TOWN OF CHAPIN
Architectural Review Board
Regular Meeting
Council Chambers, Chapin Town Hall
August 6, 2025
6:00 PM

To: Architectural Review Board
From: R. Radtke, Planning & Zoning Manager
Date: July 16, 2025
Re: Outparcel 3– Medical Office

To: Architectural Review Board
From: R. Radtke, Planning & Zoning Manager
Date: July 23, 2025
Re: Carolina Wings – Commercial Sub-division

To: Architectural Review Board
From: R. Radtke, Planning & Zoning Manager
Date: July 17, 2025
Re: Express Oil – Commercial Sub-division

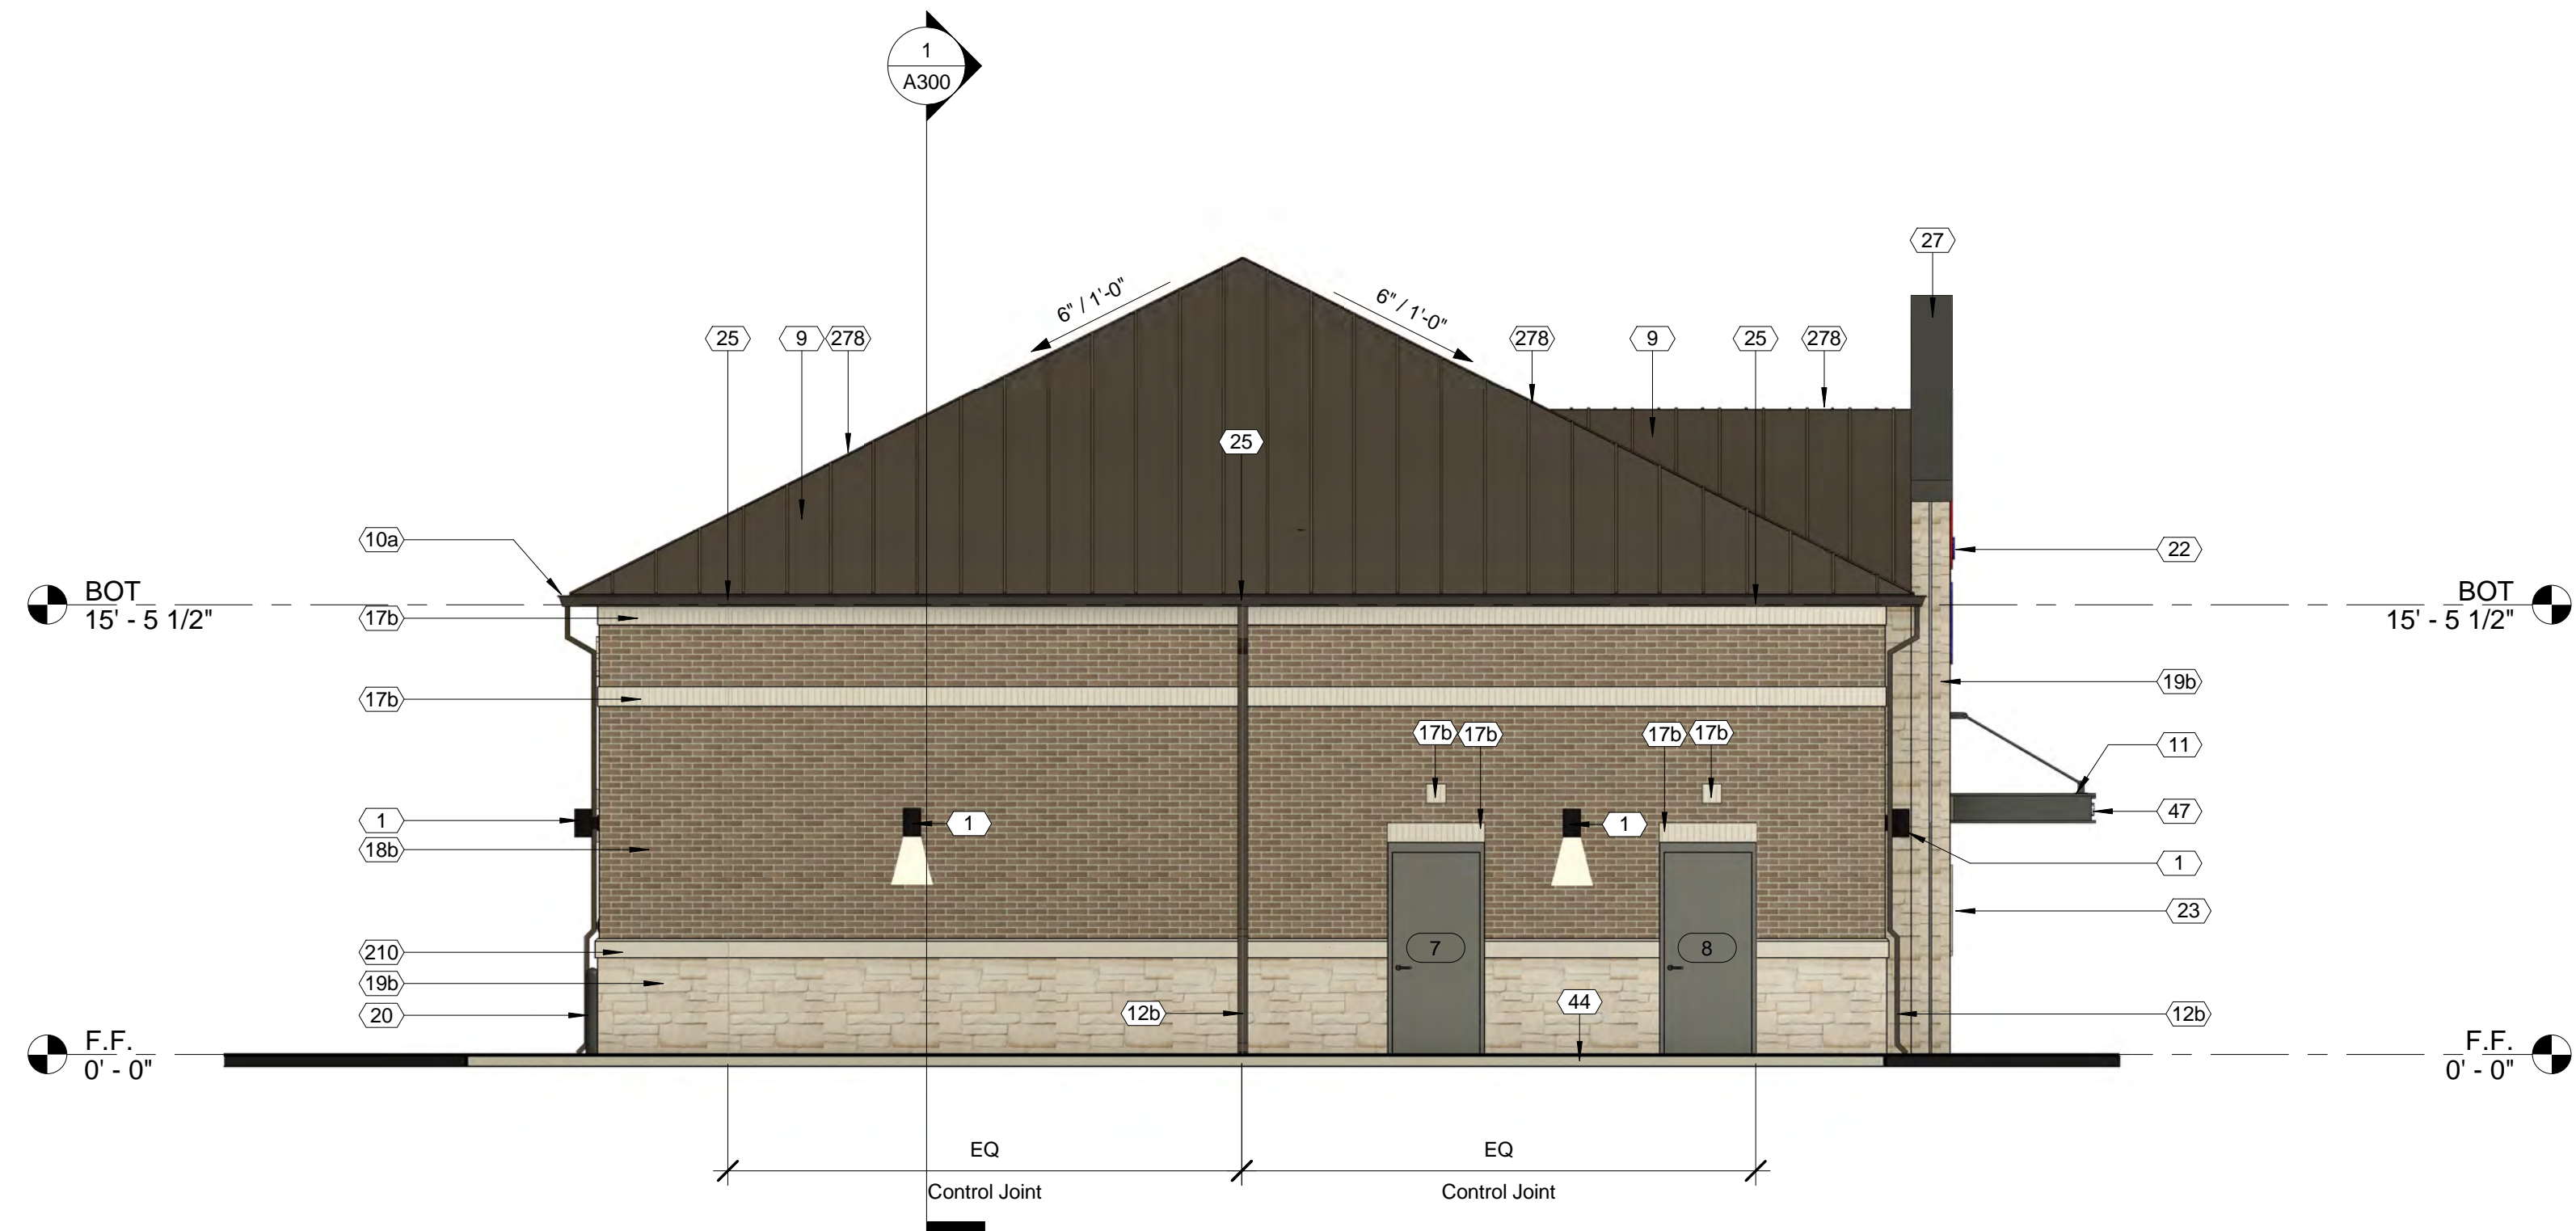
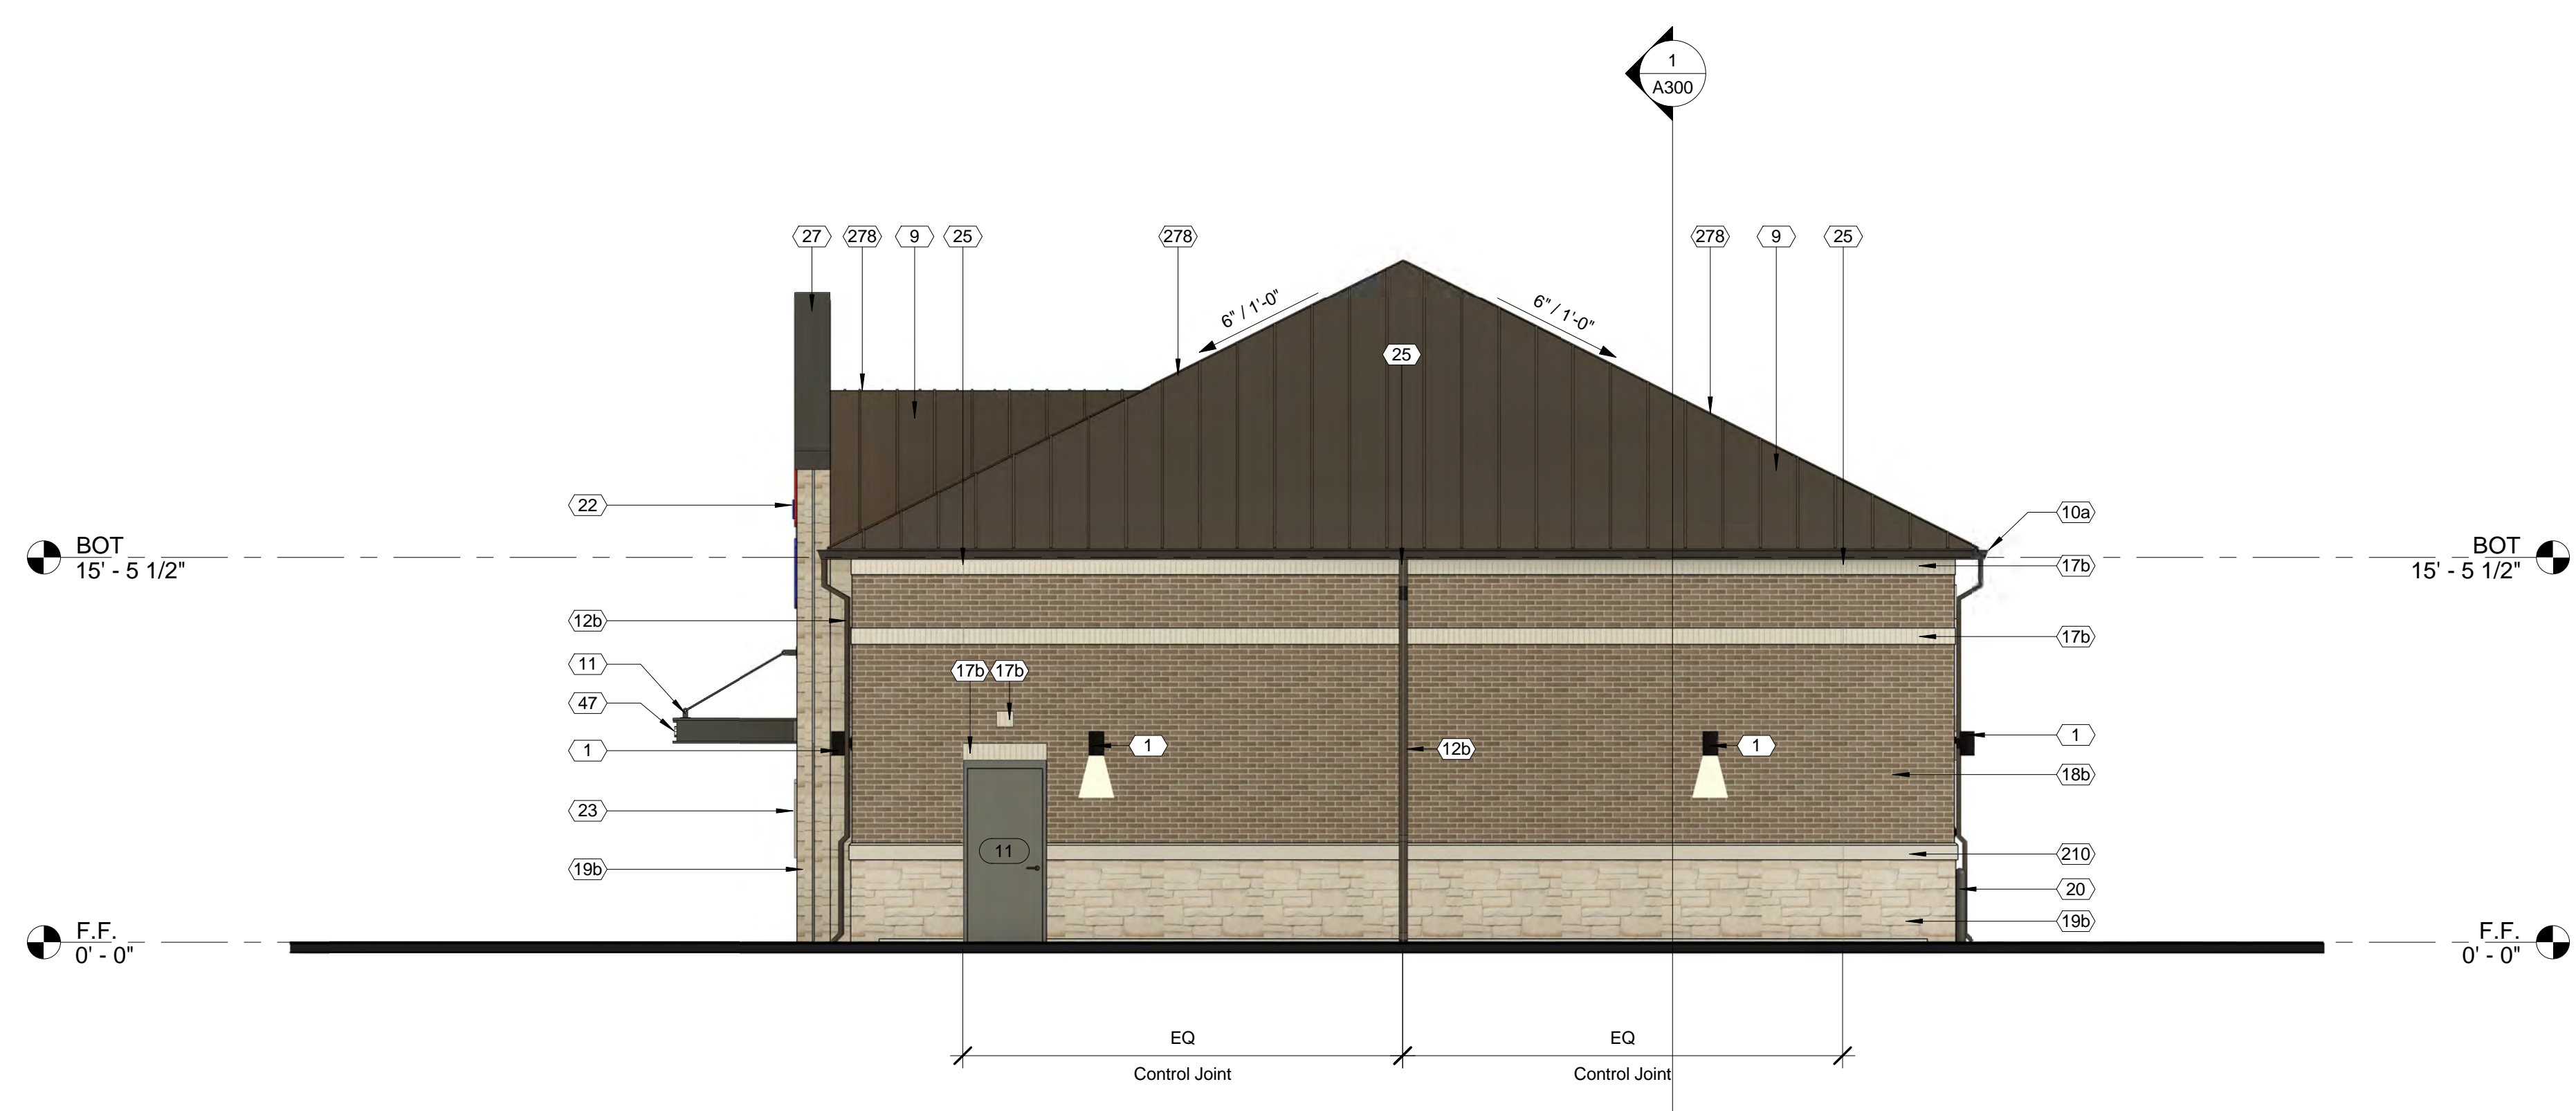
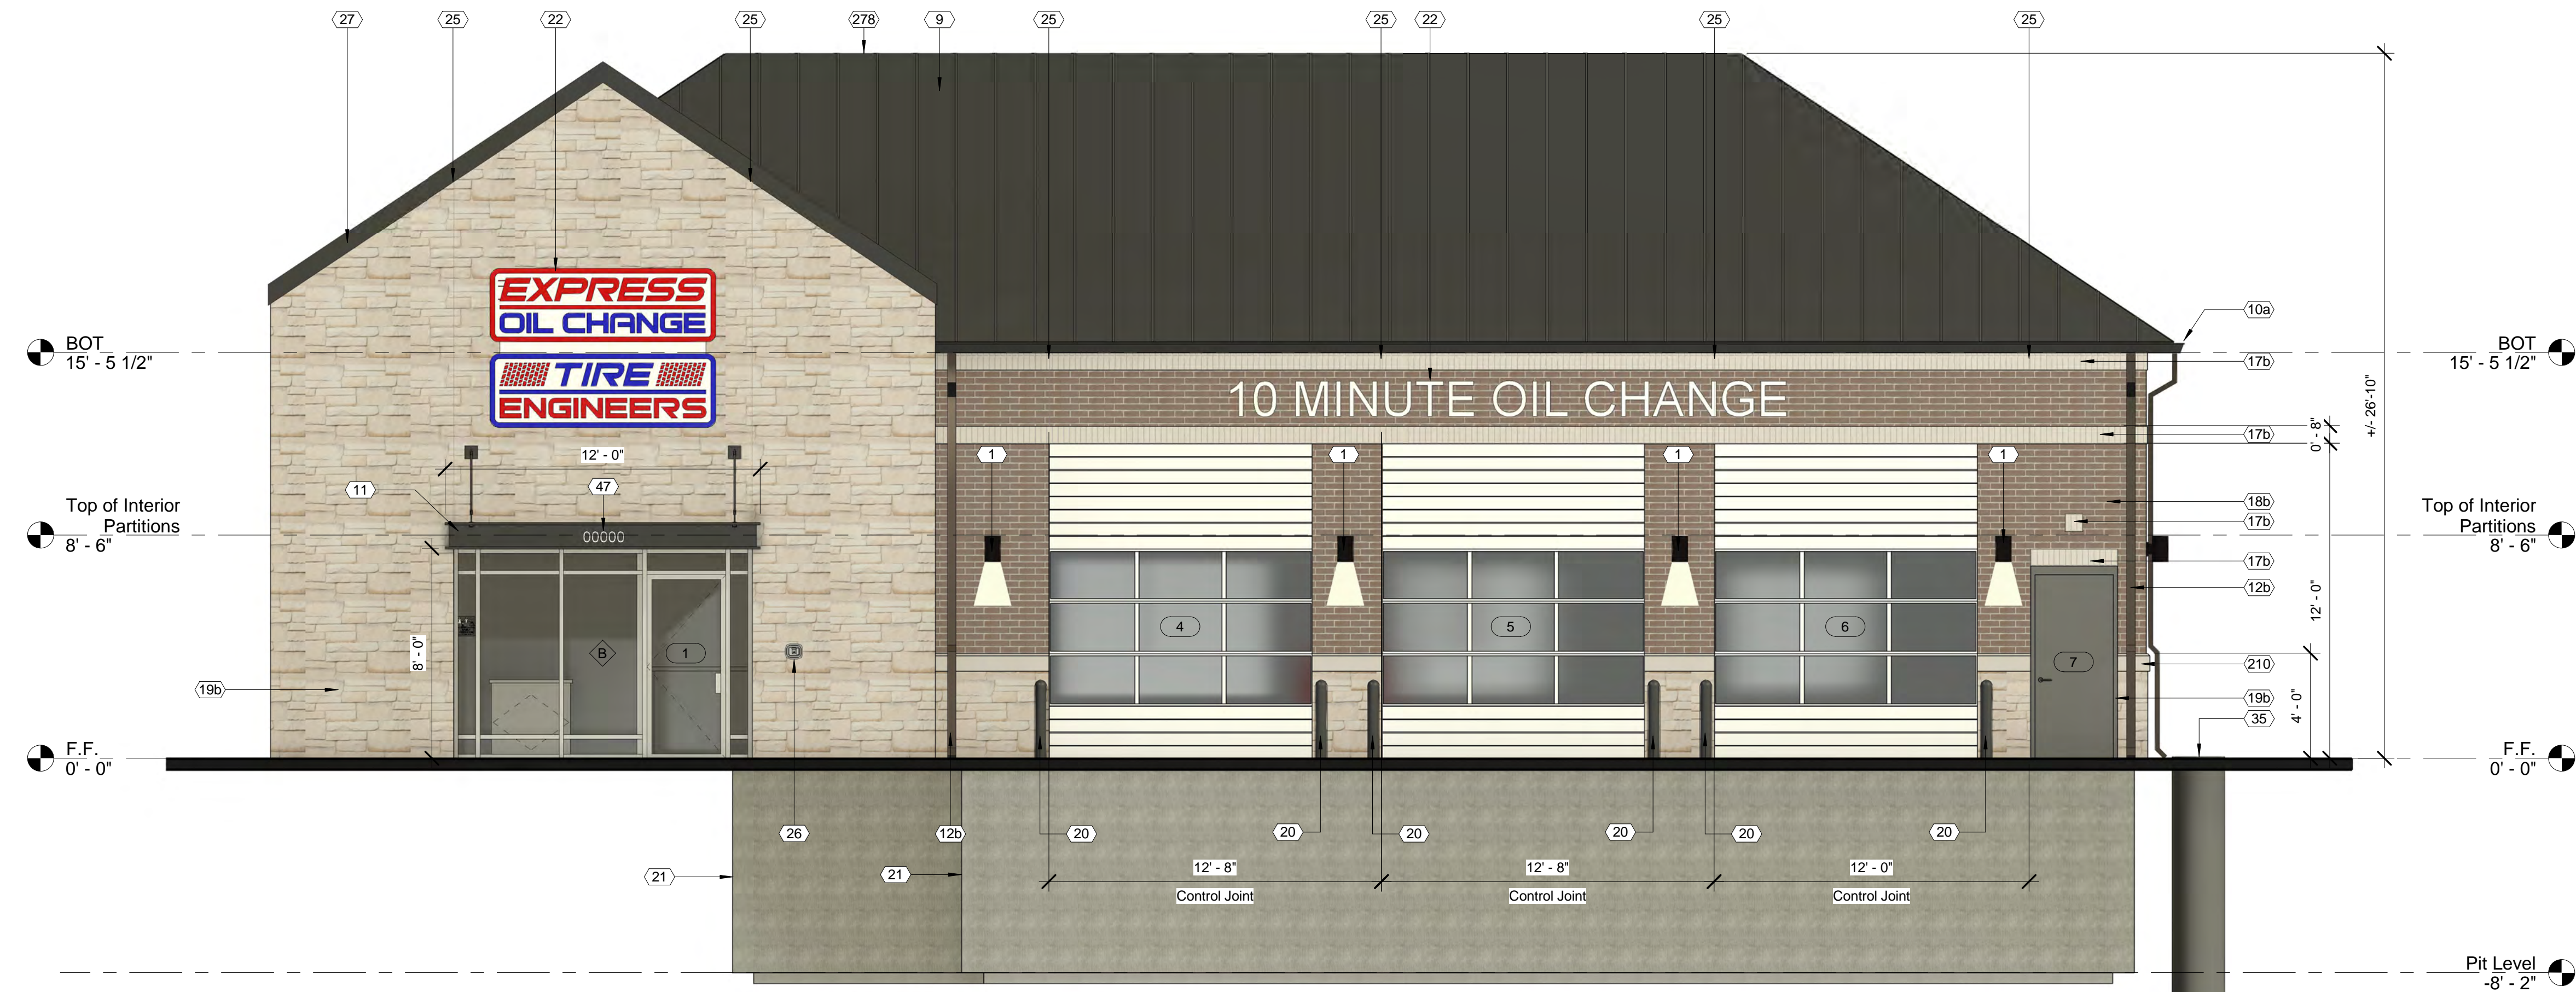
- Exterior color of building that are shown are not on the approved color pallet list. Brick colors - Dark Sandstone, Stone color - Sedona, Overhead doors - White **6.12.3.C.3.** [Approved-Color-Palette](#)
- Windows building does not meet the building frontage requirement of 30% glazing. **6.12.3.C.a**
- Parking appears to be short of the minimum required. **(Table 8.4.1)**
- Does not appear to be any landscape island dimensions. **(7.4.2.)**
- Details and locations needed for open space to be shown on plan. **(5.4.1).**
- Plan does not show any pedestrian interconnectivity as required – **8.6.3**
- No Screening of the exterior ladder or down spouts. **6.12.7.b.**
- Clarification on wall materials to building that are used for screening dumpster **6.12.7.a.**
- Confirm location of mechanical units and screening. **6.12.7.d**
